Department of Energy
National Nuclear Security Administration
Washington, DC 20585

Subject: Laboratory Response to DNFSB Letter Regarding Pu-238 Scrap Recovery Line

**LANL Response to DNFSB Letter
Regarding Pu-238 Scrap Recovery Line**

Fig. 10. Correspondence between absorbed gamma dose and years of normal operations at TA-55.

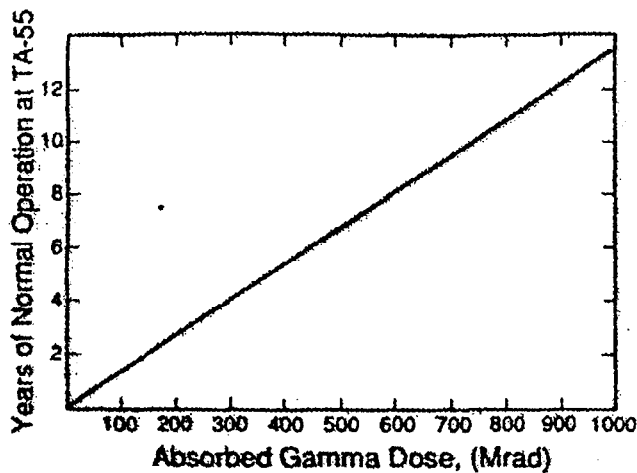
With regard to the DNFSB Staff Issue Report² concern relative to the resin dryout issue during a facility power failure and subsequent building evacuation, the DOE approval memo⁵ referenced a report entitled *The Effects of Ionizing Radiation on Reillex™ HPQ, a New Macroporous polyvinylpyridine resin, and on Four Conventional Polystyrene Anion Exchange Resins*, LA-11912, November 1990, by S. Frederic Marsh.¹⁵ To assist in clarifying this issue, an excerpt from the report is reproduced here.

As shown in Fig. 10, an absorbed dose of 370 megarads corresponds to about 5 years of normal plutonium-processing operations at the Los Alamos Plutonium Facility (TA-55), which would indicate that the threshold for the observed thermal instability of Reillex™ HPQ resin could occur only after 5 years of routine operation at TA-55. (The Los Alamos Plutonium Facility, which operates a single shift five days per week and stores ion exchange columns in 1 M nitric acid between shifts, should not be used to estimate resin lifetime elsewhere.) Because resin damage from alpha particles is lower by at least a factor of two (see the following Alpha-Particle Irradiations section), however, the threshold for the cited thermal instability of Reillex™ HPQ resin actually corresponds to more than ten years of normal operations in the Los Alamos Plutonium Facility.

The combination of two factors—the improbability of resin becoming dried and heated during production operations and the required induction period of greater than 10 years at Los Alamos—virtually eliminates any possibility that thermal instability could occur in a production environment. Nevertheless, we recommend that Reillex™ HPQ resin be replaced after not more than 5 years of service, or 700 megarads of alpha-particle irradiation, or 400 megarads of absorbed gamma dose.
